SERVICE BULLETIN

V2500-ENG-79-0076

OIL - FUEL COOLED OIL COOLER - INTRODUCTION OF AN FCOC WITH REVISED TOP MOUNT ASSEMBLY

OIL-FUEL COOLED OIL COOLER-INTRODUCTION OF NEW BUSHING

Figure 1 Set-Up Extracting-Bushing (0F25-034)

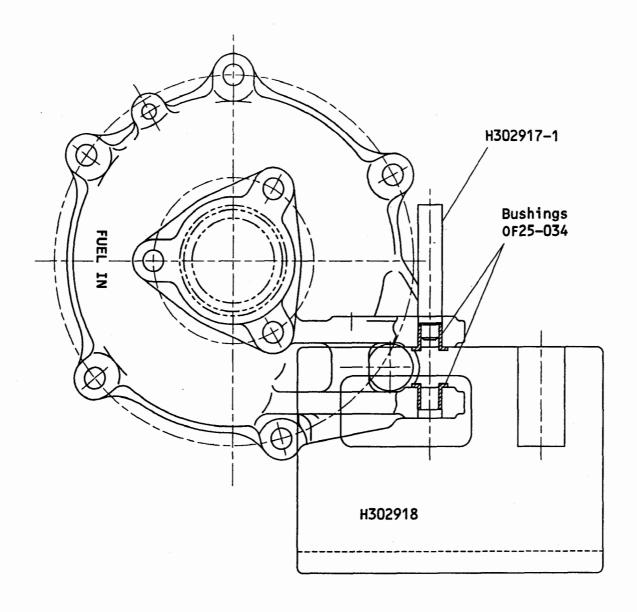
- (b) Set the Header Assy on the Tool H302918 (or equivalent) as shown on figure 1 so that the Tool H302918 (or equivalent) supports the casting lug surface of the Header Assy.

- (c) Insert the Tool H302917-1 (or equivalent) into one (1) of the Bushings, 0F25-034 with smaller diameter down on the figure 1.
 - (d) Contact the mandrel of the press with top of the Tool H302917-1 (or equivalent).

- (e) Gradually add press force until the bushing is completely extracted.
 - (f) Turn over the Header Assy and repeat (b) through (e) to extract the other Bushing.

Figure 2 Dimension to be measured on Header (0F25-114)

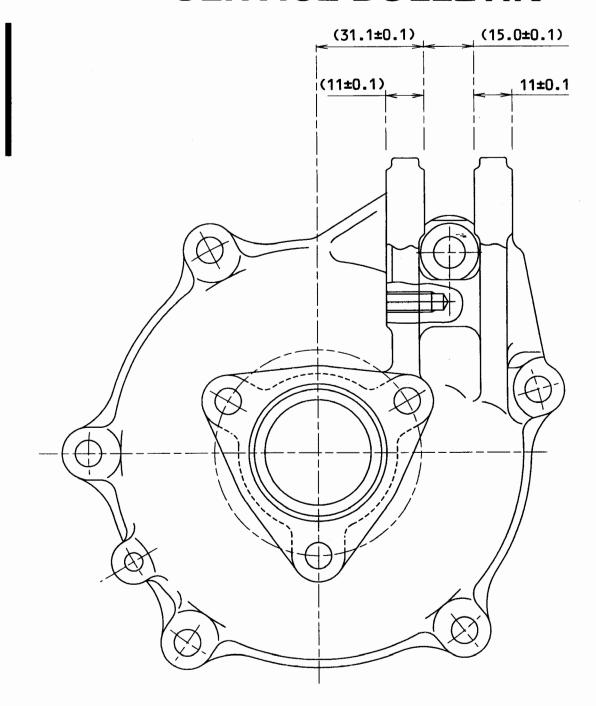
- (g) Discard the extracted two (2) Bushings.
- (3) To modify the Header from P/N 0F25-114 to 55022014-3, do these steps:
 - (a) Measure the dimension shown on figure 2. The dimension shall be 11 ± 0.1 mm.

- (b) If the dimension is larger than the specified figure, adjust the dimension by machine.
- (c) Touch up the reworked area with alodine No.1200s.
- (d) If the dimension is smaller than the specified figure, purchase a modified Header (Assy).

Figure 3 Set-Up Inserting Bushing (0F32-150)

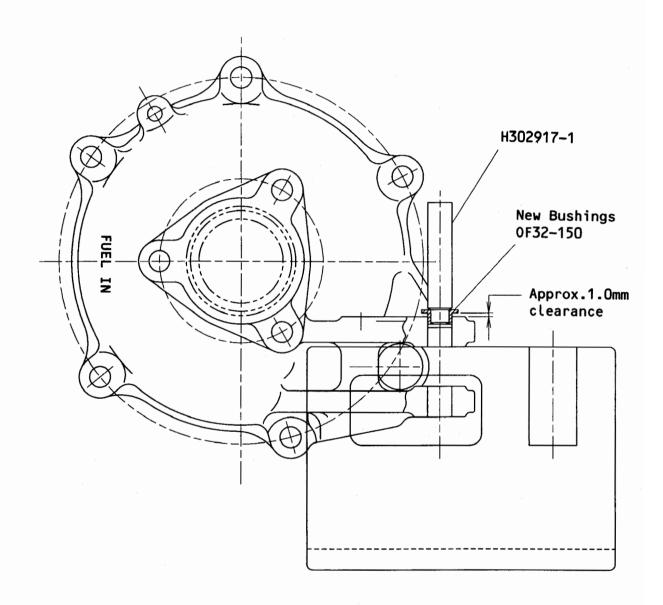
- (b) Set up the Header, primed Bushing and the Tools as shown on figure 3.
 - (c) Insert the Tool H302917-1 (or equivalent) into the primed bushing with smaller diameter portion down on the figure 3.

- (d) Contact the mandrel of the press with top of the Bar Tool H302917-1 (or equivalent).
 - (e) Gradually add press force until the clearance between the bushing flange and the casting surface decreases to approximately one (1) mm.

Figure 4 Set-Up Inserting Bushing (0F32-151)

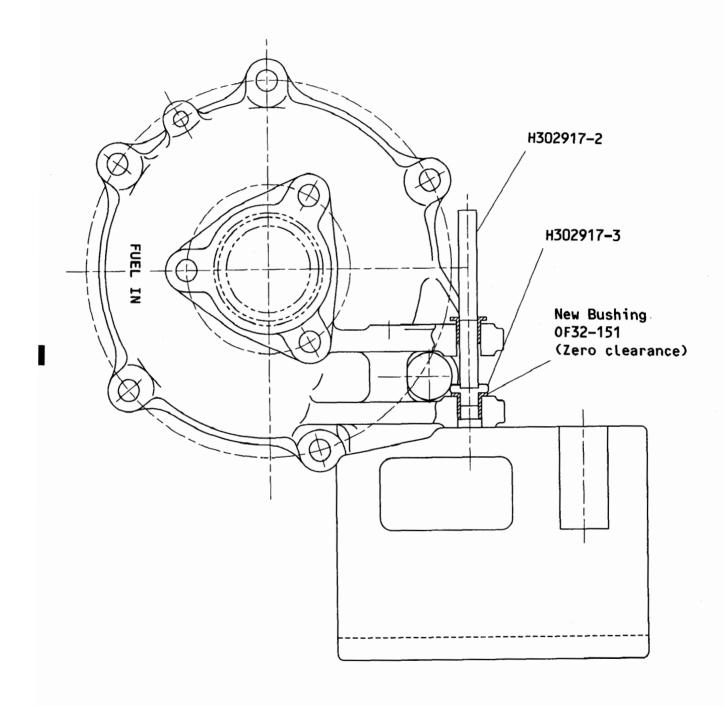
- (f) Prime the Bushing OF32-151, with TT-P-1757.
 - (g) Set up the Header, the primed Bushing and the Tools as shown on figure 4.
 - (h) Insert the Tool H302917-3 (or equivalent) into the primed Bushing and the Tool H302917-2 (or equivalent) into the Tool H302917-3 (or equivalent).

- (i) Contact the mandrel of the press with top of the Tool H302917-2 (or equivalent).
 - (j) Gradually add press force until the bushing flange contacts with the casting surface.

Figure 5 Set-Up Inserting Bushing (0F32-150)

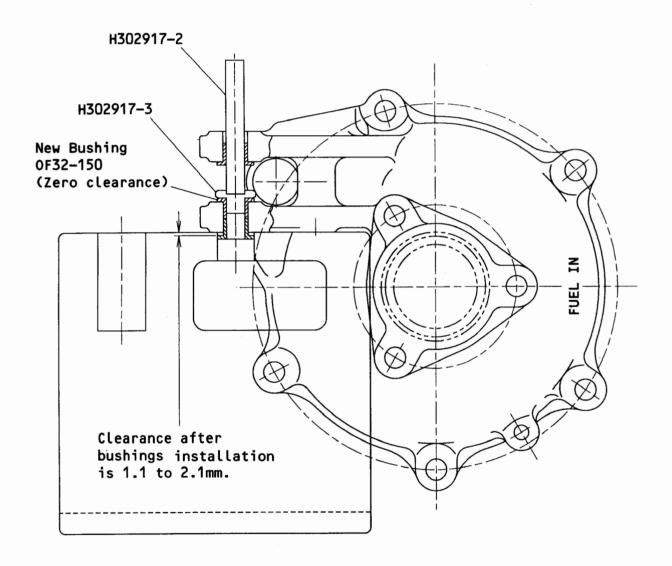
- (1) Set up the Header, the Bushing and the Tools as shown on figure 5.
- (m) Insert the Tool H302917-3 (or equivalent) into the primed Bushing and the Tool H302917-2 (or equivalent) into the Tool H302917-3 (or equivalent).
- (n) Contact the mandrel of the press with top of the Tool H302917-2 (or equivalent).
- (o) Gradually add press force until the bushing flange touch the casting surface.
- (5) To assemble the unit, use the procedure shown below:
 - (a) Replace 0-rings (P/N MS9321-11) with new ones.
 - (b) Assemble the unit in accordance with the CMM 79-21-43.
- (6) Perform proof pressure test and proof leak check in accordance with the CMM 79-21-43.
- B. Re-identification

Figure 1 Set-Up Extracting-Bushing (0F25-034)

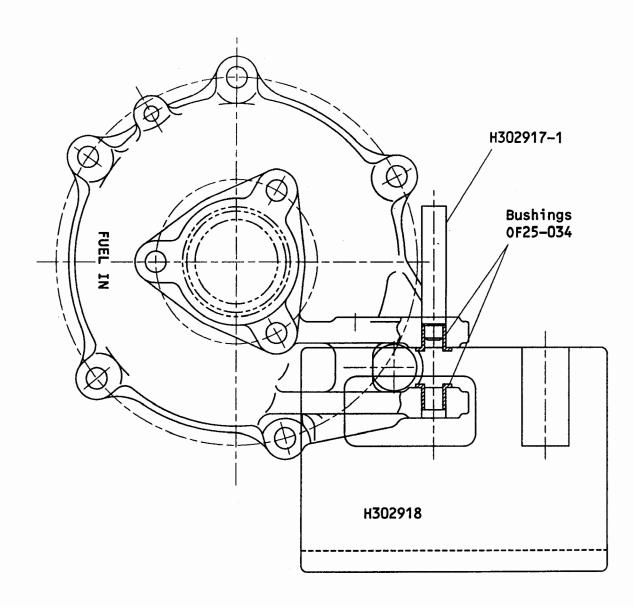
- (b) Set the Header Assy on the Tool H302918 (or equivalent) as shown on figure 1 so that the Tool H302918 (or equivalent) supports the casting lug surface of the Header Assy.

- (c) Insert the Tool H302917-1 (or equivalent) into one (1) of the Bushings, 0F25-034 with smaller diameter down on the figure 1.
 - (d) Contact the mandrel of the press with top of the Tool H302917-1 (or equivalent).

- (e) Gradually add press force until the bushing is completely extracted.
 - (f) Turn over the Header Assy and repeat (b) through (e) to extract the other Bushing.

Figure 2 Dimension to be measured on Header (0F25-114)

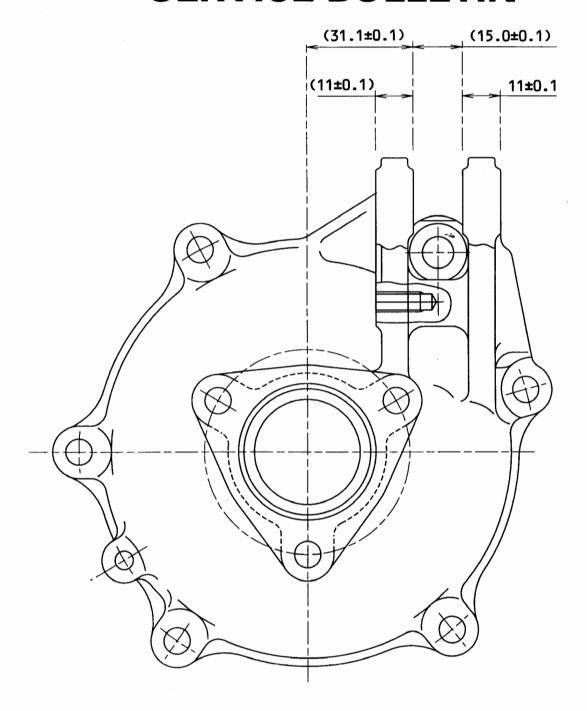
- (g) Discard the extracted two (2) Bushings.
- (3) To modify the Header from P/N 0F25-114 to 55022014-3, do these steps:
 - (a) Measure the dimension shown on figure 2. The dimension shall be 11 ± 0.1 mm.

- (b) If the dimension is larger than the specified figure, adjust the dimension by machine.
- (c) Touch up the reworked area with alodine No.1200S.
- (d) If the dimension is smaller than the specified figure, purchase a modified Header (Assy).
- (4) To install the modified Bushings, use the procedure shown below:
 - (a) Prime one of the two Bushings, OF32-150, with TT-P-1757.

Figure 3 Set-Up Inserting Bushing (0F32-150)

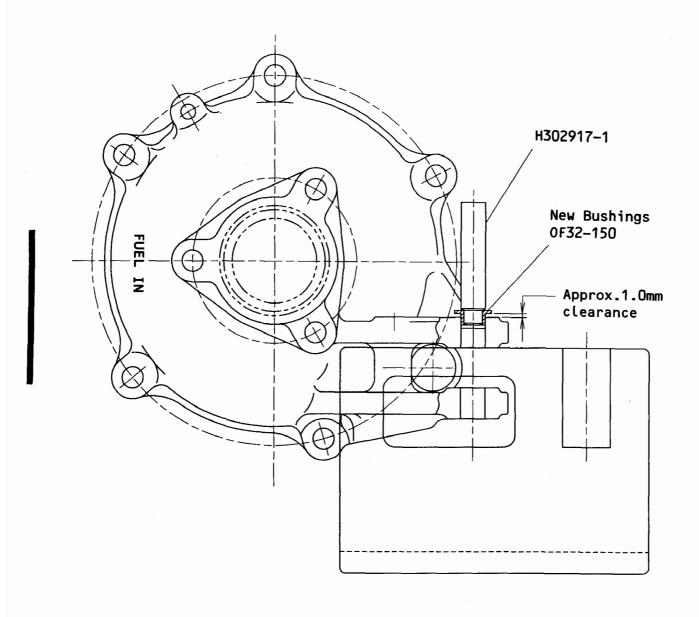
- (b) Set up the Header, primed Bushing and the Tools as shown on figure 3.
- (c) Insert the Tool H302917-1 (or equivalent) into the primed bushing with smaller diameter portion down on the figure 3.

- (d) Contact the mandrel of the press with top of the Bar Tool H302917-1 (or equivalent).
- (e) Gradually add press force until the clearance between the bushing flange and the casting surface decreases to approximately one (1) mm.

Figure 4 Set-Up Inserting Bushing (0F32-151)

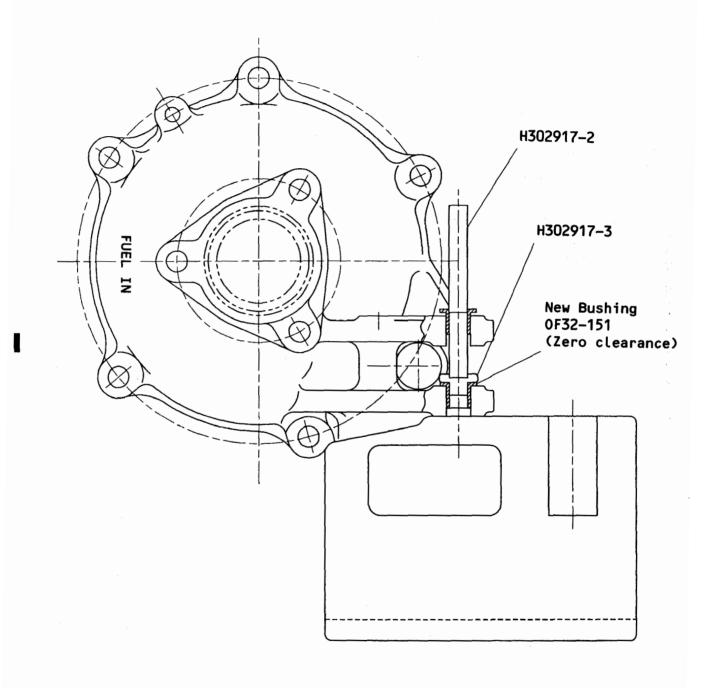
- (f) Prime the Bushing OF32-151, with TT-P-1757.
- (g) Set up the Header, the primed Bushing and the Tools as shown on figure 4.
- (h) Insert the Tool H302917-3 (or equivalent) into the primed Bushing and the Tool H302917-2 (or equivalent) into the Tool H302917-3 (or equivalent).

- (i) Contact the mandrel of the press with top of the Tool H302917-2 (or equivalent).
- (j) Gradually add press force until the bushing flange contacts with the casting surface.

Figure 5 Set-Up Inserting Bushing (0F32-150)

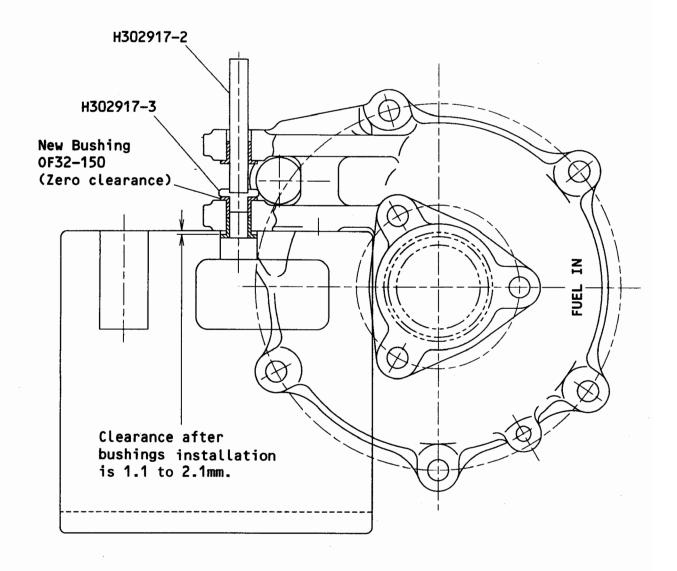
- (1) Set up the Header, the Bushing and the Tools as shown on figure 5.
- (m) Insert the Tool H302917-3 (or equivalent) into the primed Bushing and the Tool H302917-2 (or equivalent) into the Tool H302917-3 (or equivalent).
- (n) Contact the mandrel of the press with top of the Tool H302917-2 (or equivalent).
- (o) Gradually add press force until the bushing flange touch the casting surface.
- (5) To assemble the unit, use the procedure shown below:
 - (a) Replace 0-rings (P/N MS9321-11) with new ones.
 - (b) Assemble the unit in accordance with the CMM 79-21-43.
- (6) Perform proof pressure test and proof leak check in accordance with the CMM 79-21-43.
- B. Re-identification
